CRUDE-BY-RAIL: Design issues

Article 1: An Overview of the Crude-by-Rail project

The annotated Arcadis memo is attached with my comments and rebuttal to the points that Arcadis has raised. Below is an outline summary of my comments.

Valero Crude by Rail Project Sulfur Springs Setback

FIGURE

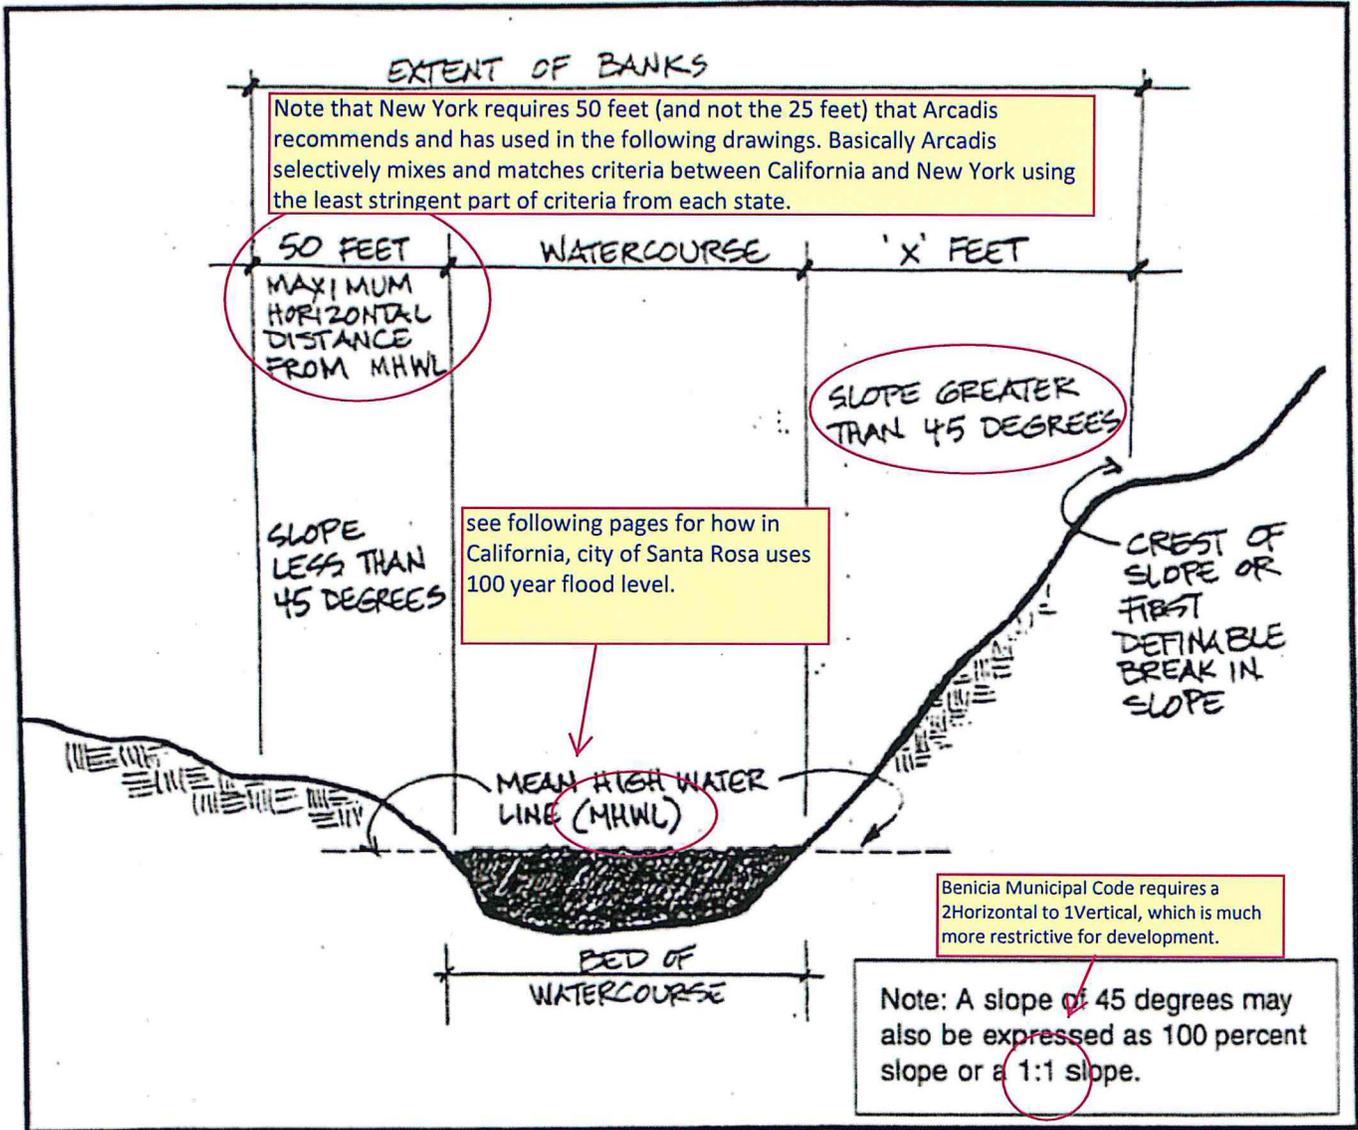
Arcadis mis-understands and mis-applies even the New York regulation. New York regulation defines top of bank as no farther than 50 feet from MHWL, and for slopes steeper than 45 degrees gives the first definable break in slope. Therefore, for slopes less steep than 45 degrees, you should use 50 feet from MHWL line for new york and by analogy 100 year flood level for Sulfur Spring.

As depicted in Figure 1 the top of bank under NYSDEC is defined as the first definable break in slope, but also is defined through a regulatory context (i.e., 50 feet from the mean high water line in instances where the grade is uniform and less than 45 degrees).

NO

This footnote was missing from Arcadis Report

VALERO ENERGY CORPORATION
CRUDE UNLOADING TRACKS
BENICIA, CA
 FEBRUARY 18, 2013 PAGE 1 OF 1

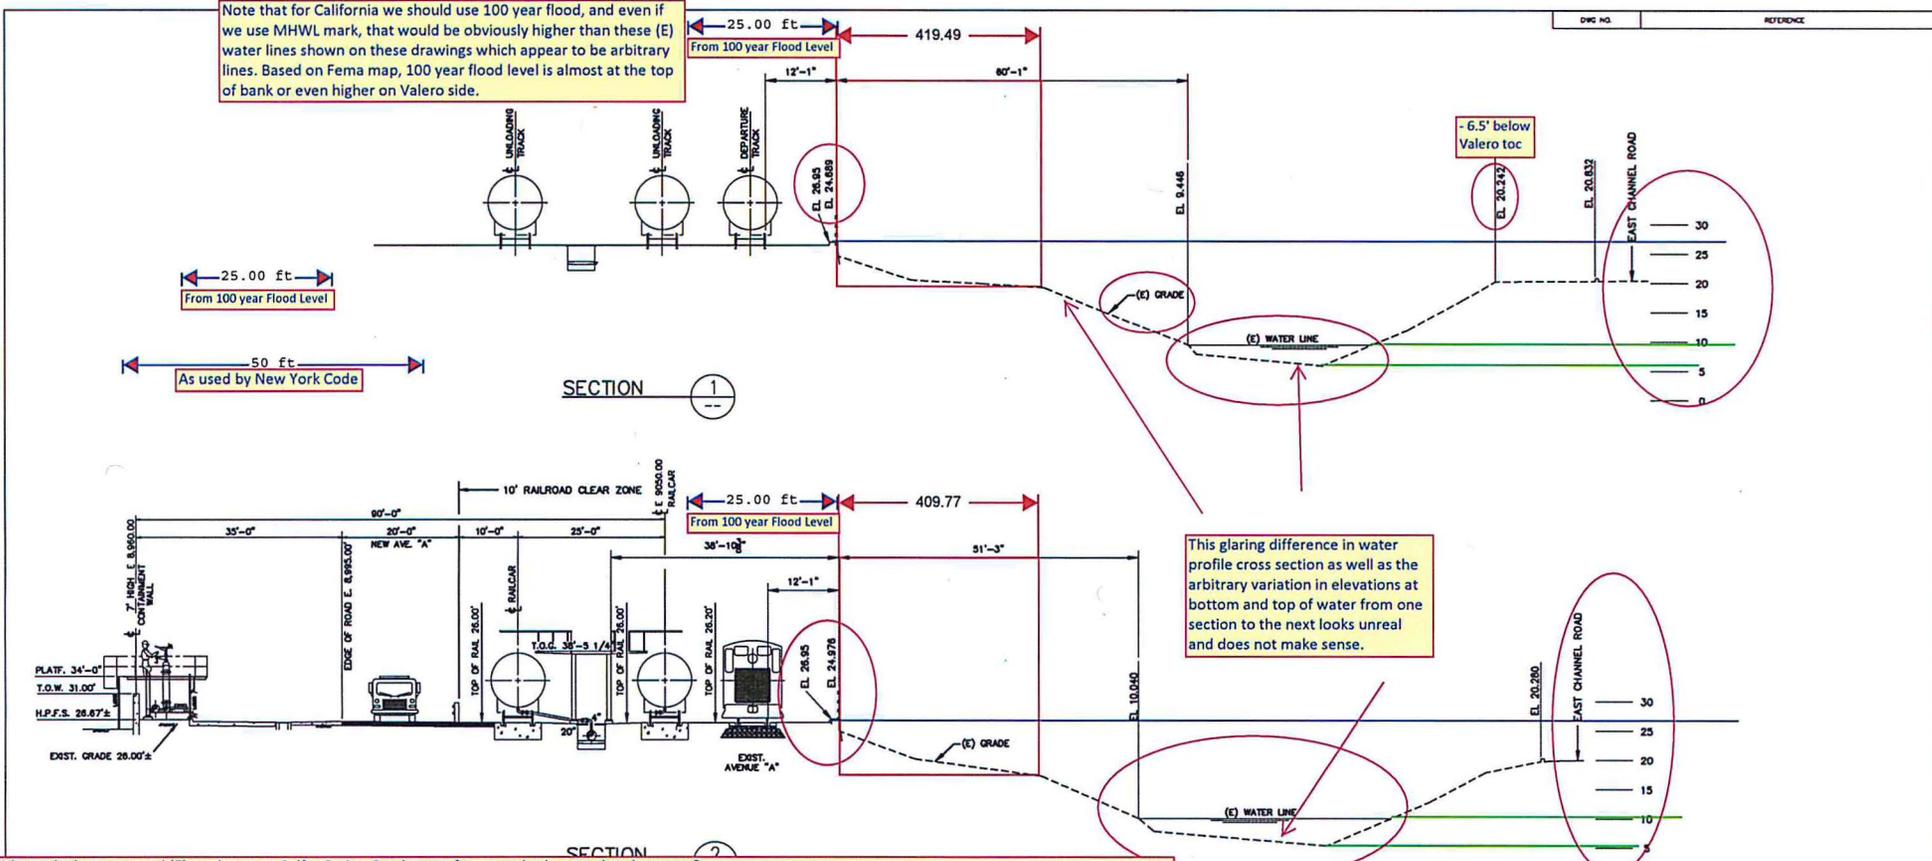
Attachment 1 of this memorandum presents the estimated distance (depicted in inches) (300 inches or 25 feet) between the current Sulphur Springs Creek top of bank and the Refinery fence line. Since the cross sections do not contain a scale, the distances must be considered estimates for final delineation of the distance from the top of the bank. Additional setback distances could be added to those identified based on the proposed development locations (i.e., rail line or unloading rack). This evaluation is summarized in the bullets below.

This is personal opinion and interpretation of Arcadis and since the authors of this memo are not licensed professional engineers or architect in California their personal beliefs are not relevant

CRUDE BY RAIL
SULFUR SPRINGS CREEK-SECTIONS

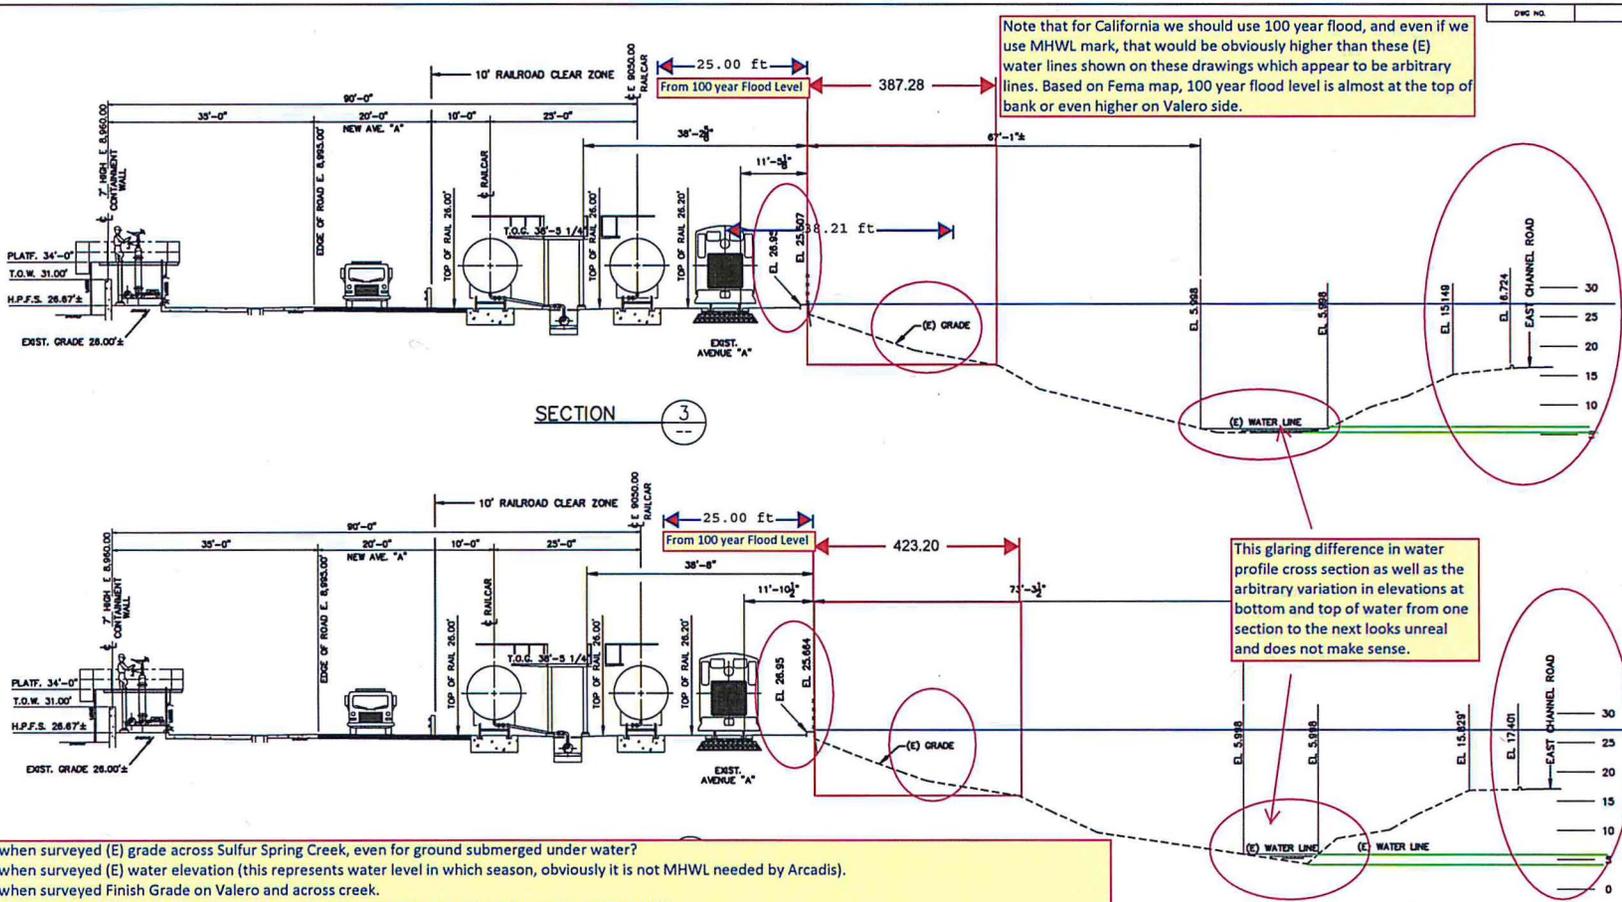
Note that for California we should use 100 year flood, and even if we use MHWL mark, that would be obviously higher than these (E) water lines shown on these drawings which appear to be arbitrary lines. Based on Fema map, 100 year flood level is almost at the top of bank or even higher on Valero side.

1. Who and when surveyed (E) grade across Sulfur Spring Creek, even for ground submerged under water?
2. Who and when surveyed (E) water elevation (this represents water level in which season, obviously it is not MHWL needed by Arcadis).

3. Who and when surveyed Finish Grade on Valero and across creek.
4. Why (E) grade on Valero side is not shown so that we see how much they are raising the grade on their side?

5. Where is the stamp and signature of surveyors and civil engineers.
6. Why these important data are being shown for the first time now in September 2016 and not in 2013 and why they are still called "STUDY"?

7. Why the City has accepted substandard drawings in 2013 with incomplete data for such an important, critical, and large project?
8. Why the City has accepted so much additional information after public review and discussion on the original permit has ended?

9. Why the City accepts drawings and engineering data from paid consultants of an applicant without their engineers name and stamp being shown on the drawing?

10. The City staff and concerned citizens that follow these proceedings are being treated badly by Valero, since we are spending considerable amount of time and effort reviewing incomplete and improperly prepared documents, and unlike corporations we do not get to deduct these from our taxes as cost of doing business.

11. Based on FEMA flood map 634 dated 1/12/2015 Valero Avenue A is fully to partially flooded and is in Regulatory Floodway Zone, also some historical photos show the Sulfur Spring banks to be at about the same elevation on north and south sides. Moreover, Valero existing finish grade looks unnaturally much higher than the grade across the creek (east channel road) in sections 1 through 8 compared to sections 9 and 10 and this appears to suggest that the refinery site has been raised artificially to make that property more useful and less prone to flood damage and consequently more valuable. But this has not been a win-win situation for the properties on the other side of the creek and even downstream from the site. As a result of regrading, their properties have been adversely affected for being on the lower and therefore losing side. They have become more prone to flood damage which would reduce their property values, increase their flood insurance rates, and increase risks of injury and damage. Such changes to grading and drainage of a flood plain zone are serious matter and should have been reviewed and approved by the City and reported to other state agencies as well. Where are the records of this important change to the natural terrain?

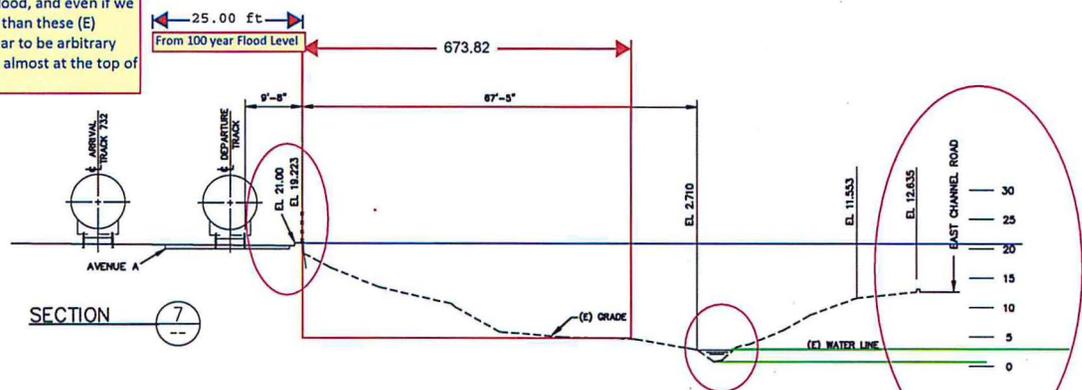
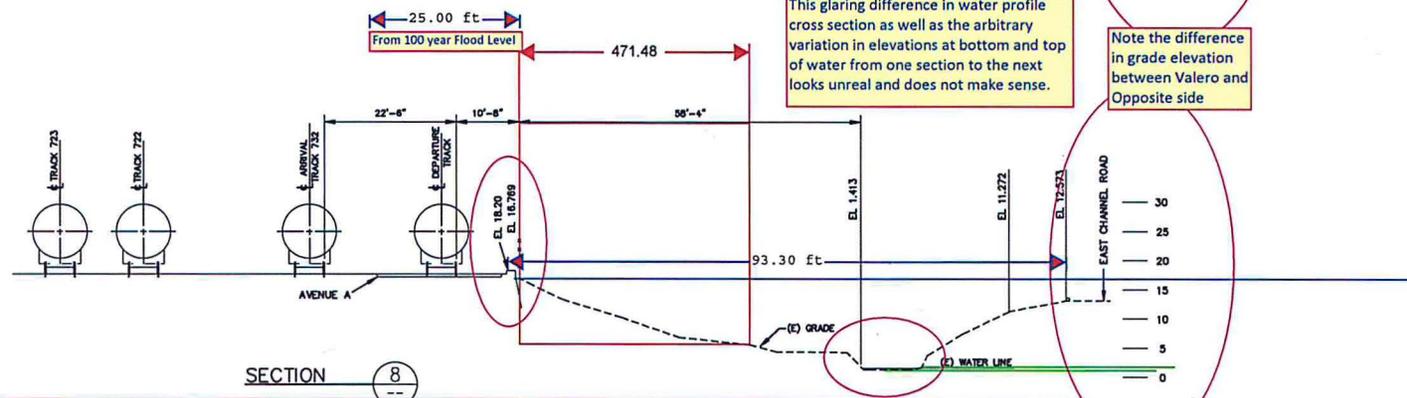
Note that for California we should use 100 year flood, and even if we use MHWL mark, that would be obviously higher than these (E) water lines shown on these drawings which appear to be arbitrary lines. Based on Fema map, 100 year flood level is almost at the top of bank or even higher on Valero side.

This glaring difference in water profile cross section as well as the arbitrary variation in elevations at bottom and top of water from one section to the next looks unreal and does not make sense.

1. Who and when surveyed (E) grade across Sulfur Spring Creek, even for ground submerged under water?
2. Who and when surveyed (E) water elevation (this represents water level in which season, obviously it is not MHWL needed by Arcadis).

9. Why the City accepts drawings and engineering data from paid consultants of an applicant without their engineers name and stamp being shown on the drawing?

11. Based on FEMA flood map 634 dated 1/12/2015 Valero Avenue A is fully to partially flooded and is in Regulatory Floodway Zone, also some historical photos show the Sulfur Spring banks to be at about the same elevation on north and south sides. Moreover, Valero existing finish grade looks unnaturally much higher than the grade across the creek (east channel road) in sections 1 through 8 compared to sections 9 and 10 and this appears to suggest that the refinery site has been raised artificially to make that property more useful and less prone to flood damage and consequently more valuable. But this has not been a win-win situation for the properties on the other side of the creek and even downstream from the site. As a result of regrading, their properties have been adversely affected for being on the lower and therefore loosing side. They have become more prone to flood damage which would reduce their property values, increase their flood insurance rates, and increase risks of injury and damage. Such changes to grading and drainage of a flood plain zone are serious matter and should have been reviewed and approved by the City and reported to other state agencies as well. Where are the records of this important change to the natural terrain?

Note that for California we should use 100 year flood, and even if we use MHWL mark, that would be obviously higher than these (E) water lines shown on these drawings which appear to be arbitrary lines. Based on Fema map, 100 year flood level is almost at the top of bank or even higher on Valero side.

This glaring difference in water profile cross section as well as the arbitrary variation in elevations at bottom and top of water from one section to the next looks unreal and does not make sense.

Note the difference in grade elevation between Valero and Opposite side

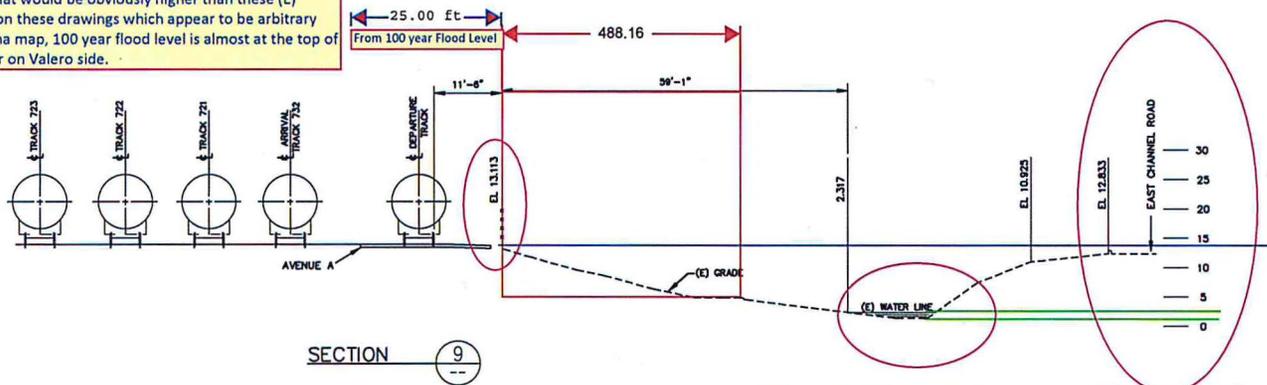
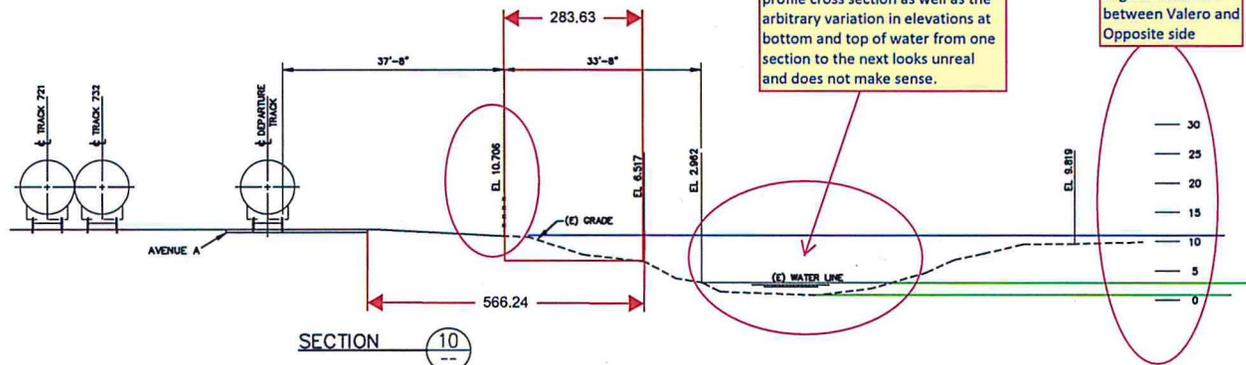
Note that for California we should use 100 year flood, and even if we use MHWL mark, that would be obviously higher than these (E) water lines shown on these drawings which appear to be arbitrary lines. Based on Fema map, 100 year flood level is almost at the top of bank or even higher on Valero side.

SECTION 9

This glaring difference in water profile cross section as well as the arbitrary variation in elevations at bottom and top of water from one section to the next looks unreal and does not make sense.

Note the difference in grade elevation between Valero and Opposite side

9. Why the City accepts drawings and engineering data from paid consultants of an applicant without their engineers name and stamp being shown on the drawing?

11. Based on FEMA flood map 634 dated 1/12/2015 Valero Avenue A is fully to partially flooded and is in Regulatory Floodway Zone, also some historical photos show the Sulfur Spring banks to be at about the same elevation on north and south sides. Moreover, Valero existing finish grade looks unnaturally much higher than the grade across the creek (east channel road) in sections 1 through 8 compared to sections 9 and 10 and this appears to suggest that the refinery site has been raised artificially to make that property more useful and less prone to flood damage and consequently more valuable. But this has not been a win-win situation for the properties on the other side of the creek and even downstream from the site. As a result of regrading, their properties have been adversely affected for being on the lower and therefore loosing side. They have become more prone to flood damage which would reduce their property values, increase their flood insurance rates, and increase risks of injury and damage. Such changes to grading and drainage of a flood plain zone are serious matter and should have been reviewed and approved by the City and reported to other state agencies as well. Where are the records of this important change to the natural terrain?
